UNITED STATES PATENT AND TRADEMARK OFFICE

10/779,864

Office Action Summary

DETAILED ACTION

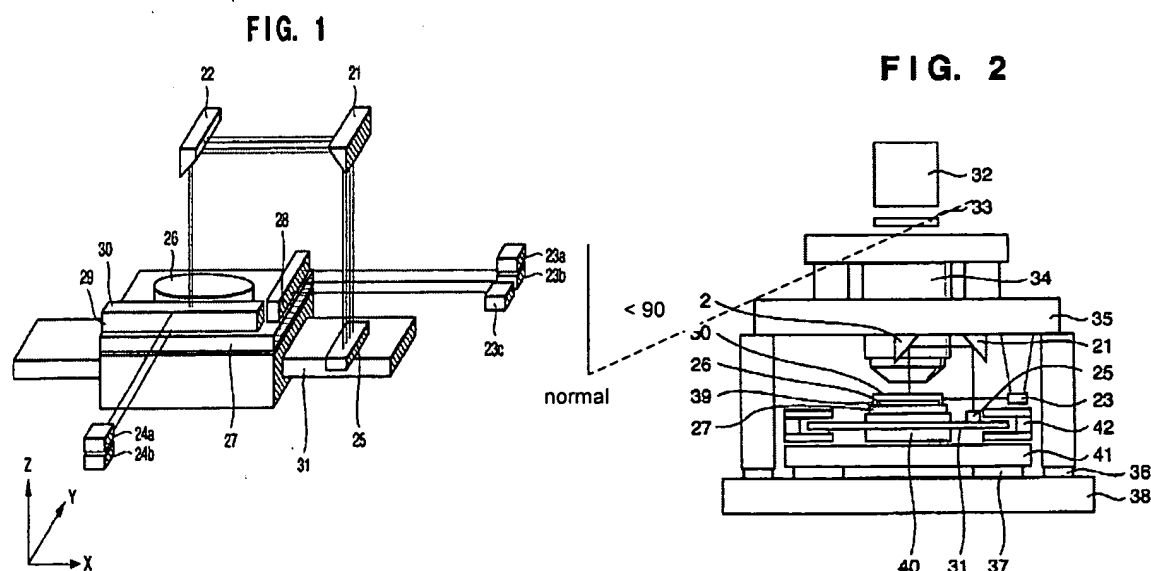
As to claims 1 and 2, Takai et al disclose providing a reference laser beam (column 9, line 57); providing a measuring laser beam (column 9, line 57); reference and measuring laser beams are provided by Z-measuring interferometer 25 in figure 2 shown below; the measuring laser beam is directed substantially perpendicularly incident (column 14, lines 56-59) on a measuring mirror with a fixed position relative to an object (z-measuring mirror 30 is fixed to the top stage 27, which holds the wafer chuck/object as described in column 6, lines 38-43 and column 7, lines 55-59); the normal to the z-measuring mirror 21 may also make a non-zero acute angle with the z-direction (see lines extending from the mirror, as drawn by the examiner and the explanation in column 7, lines 22-27); partly overlapping the reference and measuring beams creates an interference signal by definition; determining a change in the interference signal (column 7, lines 45-54); processing the change to determine displacement of the object along the z-direction (column 7, line 60 thru column 8, line 2).

As to claims 18 and 19, Takai et al disclose, in figure 3, additional measuring mirrors, 21, 22, with acute angles with respect to the z-direction (see also the normal drawn in figure 2 above). The two mirrors 21, 22 are on opposite sides of the holder as shown in figure 3.
